MIL-C-20/39C
AMENDMENT 3
6 June 1984
SUPERSEDING
AMENDMENT 2
18 January 1980

MILITARY SPECIFICATION SHEET

CAPACITORS, FIXED, CERAMIC DIELECTRIC
(TEMPERATURE COMPENSATING),
ESTABLISHED AND NON-ESTABLISHED RELIABILITY,
STYLES CCR15 AND CC15, CCR19 AND CC19

This amendment forms a part of Military Specification Sheet MIL-C-20/39C, dated 5 November 1976, and is approved for use by all Departments and Agencies of the Department of Defense.

FIGURE 1. Styles CCR15, CC15, CCR19 and CC19 capacitors.

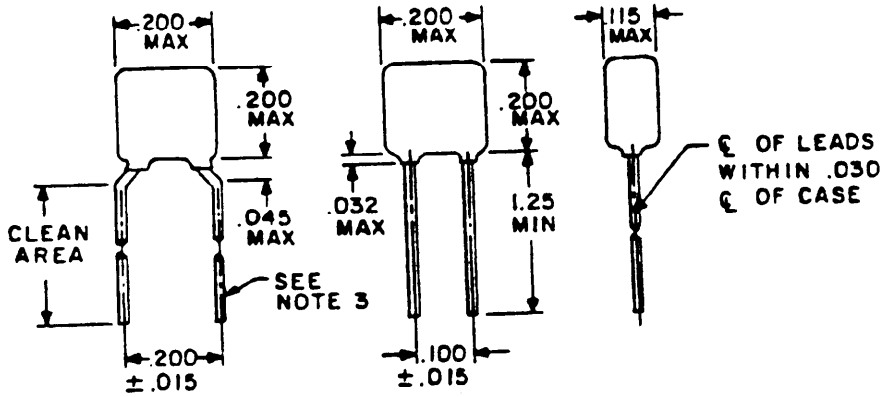
Figure 1, delete and substitute:

NOTES:
1. Dimensions are in inches.
2. Metric equivalents are given for general information only.
3. Lead diameter shall be .025 ±.002.
